**Town of Randolph  
Zapustas Arena**

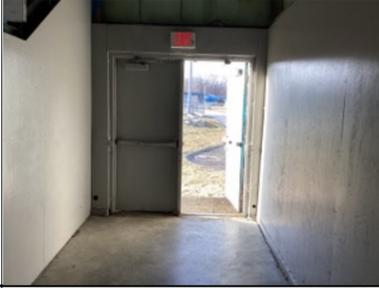
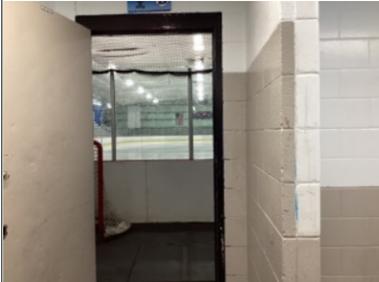
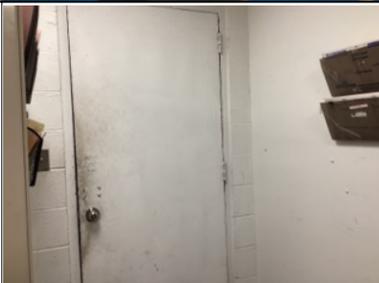
ID	Location	Floor	Room	Element	Type	Photo	Issues	Current Measure	Recommendations	Quantity	Price	Cost Estimation
<b>Approach and Entrance</b>												
<b>Exterior Access Route</b>												
1	North Exit	Ext.		Exterior Access Route	Exterior		Accessible route not provided	-	Ensure an accessible route is provided. (Provide a stable, firm and slip resistant accessible route with a change in level no greater than 1/4" from the north exit egress door landing to the parking lot. When this is done, when the interior illuminated exit sign at this door is serviced or replaced, provide an illuminated International Symbol of Accessibility (ISA) to indicate the availability of an accessible means of egress.)	1	-	\$0
<b>Off-Street Parking Lot or Garage</b>												
2	Parking	Ext.		Off-Street Parking Lot or Garage	Visitor		Total # of parking Total # of designated van accessible spaces Access aisle not compliant Access aisle < 60" wide at car/van space Sign not provided	100 3 - 4'8" -	Provide a marked access aisle that is at least 60" wide at each of the three (3) car accessible parking spaces (re-stripe). Provide a sign with the International Symbol of Accessibility (ISA) at each car accessible space with the bottom of the sign 60" min. above the ground and the top 96" max. above the ground.	3	-	\$0

3	Parking	Ext.		Off-Street Parking Lot or Garage	Visitor		Total # of designated van accessible spaces Running or cross slope at space > 1:50 (2.00%) Sign does not have the designation "Van Accessible" Sign bottom < 60" above finished grade	1 3.5% - 48"	Reduce running or cross slope to be no steeper than 1:50 (2.00%). Add the designation "Van Accessible" to the sign located at the van accessible space. Locate sign with the bottom of the sign 60" above the ground.	1	-	\$0
<b>Access to Goods and Services</b>												
<b>Means of Egress</b>												
4	Main Entrance	1		Means of Egress			Tactile exit sign not provided Illuminated ISA symbol not provided (MAAB)		Ensure tactile exit signs with raised characters and braille are provided at exit doors. Mount signs between 48"- 60" above the finished floor located on the latch side of the door. When the exit sign is replaced with a new illuminated exit sign, provide an illuminated International Symbol of Accessibility (ISA).	1	232	\$232

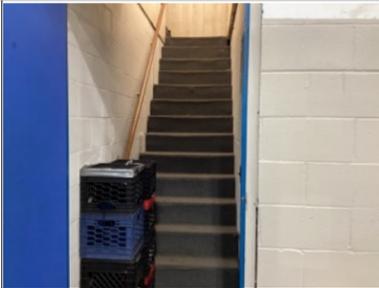
ID	Location	Floor	Room	Element	Type	Photo	Issues	Current Measure	Recommendations	Quantity	Price	Cost Estimation
5	North Exit	1		Means of Egress	N/A		Tactile exit sign not provided Directional sign to accessible emergency exit not provided	-	Ensure tactile exit signs with raised characters and braille are provided at exit doors. Mount signs between 48"- 60" above the finished floor located on the latch side of the door. Provide a directional sign indicating the location of the nearest accessible emergency exit.	1	464	\$464
6	North Center Exit	1		Means of Egress			Tactile exit sign not provided Directional sign to accessible emergency exit not provided		Ensure tactile exit signs with raised characters and braille are provided at exit doors. Mount signs between 48"- 60" above the finished floor located on the latch side of the door. Provide a directional sign indicating the location of the nearest accessible emergency exit.	2	232	\$464

<b>Interior Access Route</b>												
7	By Rink	1		Interior Access Route	N/A		Obstructed by protruding objects	8.5"	Provide a cane-detectable barrier under counter.	1	306	\$306
8	Door to Rink	1		Interior Access Route	111		Level changes > 1/4" Accessible route not provided	6" -	Alter change in level to be 1/4" high max. Provide an accessible route to rink. (IHCD team was told that the transition at this door is being made level on the side of the door that is outside of the ice rink. An approximately 6" drop will remain on the ice side of the door.)	1	-	\$0
9	Around Rink	1		Interior Access Route	N/A		Level changes > 1/4" Accessible route not provided	-	Alter change in level to be 1/4" high max. Provide an accessible route. (Reposition rubber mats to create an accessible surface prior to installation of new floor.)	1	Labor	\$0

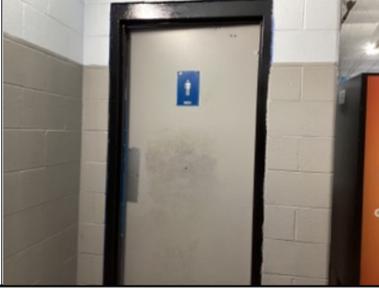
ID	Location	Floor	Room	Element	Type	Photo	Issues	Current Measure	Recommendations	Quantity	Price	Cost Estimation
10	Zamboni Entrance and Accessible Route to Ice	1		Interior Access Route	N/A		Level changes > 1/4" Accessible route not provided	.75" -	Alter change in level to be 1/4" high max. Ensure an accessible route is provided to this entry point once it is made accessible.	1	150	\$150
11	Birthday Room	2		Interior Access Route	N/A		Accessible route not provided		Provide a comparable space on an accessible route on the first floor for birthday parties, meetings and the like.	1	Labor	\$0
<b>Doors, Doorways, &amp; Gates</b>												
12	Locker Room 7/8 Towards Rink	1		Doors, Doorways, & Gates	Circulation		Maneuvering clearance(s) not provided	8"	Provide an automatic door opener or provide 8" min. pull-side maneuvering clearance at the door. (Cost based on the installation of an automatic door opener.)	1	3060	\$3060

13	Women's Public Event Attendee Toilet Room	1		Doors, Doorways, & Gates	Toilet Room		Maneuvering clearance(s) not provided	33"	Provide 42" min. turning maneuvering clearance at the door or, if that is technically infeasible, provide an accessible single-user toilet room for female rink visitors who are present to witness rink activities (i.e., as opposed to skaters who could use a locker room toilet room.)	1	24604	\$24604
14	Referee Room Exit Door	1		Doors, Doorways, & Gates	Other		Maneuvering clearance(s) not provided	10"	Provide an automatic door opener.	1	3060	\$3060

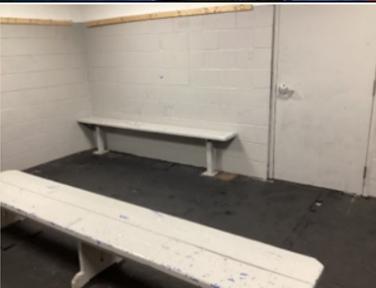
ID	Location	Floor	Room	Element	Type	Photo	Issues	Current Measure	Recommendations	Quantity	Price	Cost Estimation
15	North Exit	Ext.		Doors, Doorways, & Gates			Threshold > 1/2" high	4"	Alter the threshold to be 1/2" high max.	1	150	\$150
16	Referee Room Entry Door	1		Doors, Doorways, & Gates			Hardware not operable with a closed fist		Provide hardware that can be operable with one hand and not require tight grasping, pinching, or twisting of the wrist.	1	484	\$484
17	Coaches Room	1		Doors, Doorways, & Gates	Circulation		Hardware not operable with a closed fist	-	Provide hardware that can be operable with one hand and not require tight grasping, pinching, or twisting of the wrist.	1	484	\$484
<b>Stairways</b>												
18	Route to Birthday Party Gathering Room	1		Stairways			Handrails do not extend 12" from stairs Handrail not provided on both sides		Provide handrail on one side. Bottom: Ensure handrails extend to one tread depth beyond the last riser.	1	-	\$0

<b>Signage</b>												
19	Women's Public Event Attendee Toilet Room	1		Signage	Designation		Raised characters not provided on sign Raised characters < 48" or > 60" above ground Directional sign to access. toilet not provided	63" -	Provide text with raised characters duplicated in braille on sign. Mount signs so that the baseline of the lowest tactile character is 48" min. above finished floor and the baseline of the highest tactile character is 60" max. above the finished floor. Install a sign indicating the location of the nearest accessible toilet room.	2	232	\$464

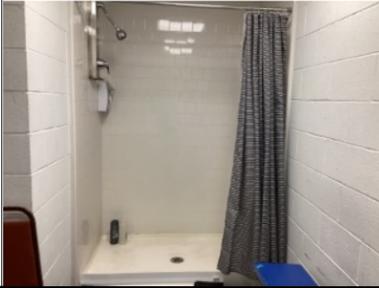
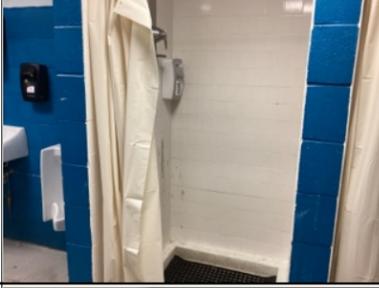
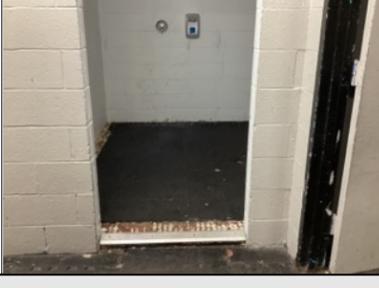
ID	Location	Floor	Room	Element	Type	Photo	Issues	Current Measure	Recommendations	Quantity	Price	Cost Estimation
<b>Lavatory</b>												
34	Referee Room	1		Lavatory	N/A		Clear floor space not provided at lavatory Plumbing underneath is exposed		Provide at least one lavatory with a 30" min. by 48" min. clear floor space positioned for a forward approach. (Relocate stored items.) Insulate or otherwise configure pipes to prevent contact for at least one lavatory.	1	92	\$92
35	Men's Public Event Attendee Toilet Room	1		Lavatory	N/A		Toe or knee clearances not provided		Provide at least one lavatory with knee and toe clearance positioned for a forward approach.	1	1686	\$1686
36	Toilet Room 7/8	1		Lavatory	N/A		Faucet is not operable with a closed fist Plumbing underneath is exposed		Provide a faucet that can be operable with one hand and not require tight grasping, pinching, or twisting of the wrist for at least one lavatory. Insulate or otherwise configure pipes to prevent contact for at least one lavatory.	1	1078	\$1078

<b>Single-User Toilet</b>												
37	Locker Room 7/8	1		Single-User Toilet	N/A		Flush control not on open side Centerline < or > 18" (MAAB) Grab bar not provided Clearance at toilet < 60" clear width	- 23" - -	Relocate the flush control to the open side. Relocate toilet so that the centerline is 18" from the side wall. Provide one grab bar on the side wall of the toilet and one on the rear wall. Ensure that there is 60" wide min. clear floor space at the toilet. (Remove urinal.)	1	6928	\$6928
<b>Toilet Compartment</b>												
38	Referee Room	1		Toilet Compartment	Accessible Compartment		Door has incorrect swing Door has malfunctioning self-closing hinge Coat hook > 48" (2010 ADA) Door pull not provided	- - 66" -	Reverse swing at door and replace keeper. Repair hinge. Locate the coat hook no higher than 48" above the finished floor. Provide a door pull on each side of the door between 34" to 48" above the finished floor that does not require tight grasping, pinching or twisting of the wrist.	1	406	\$406
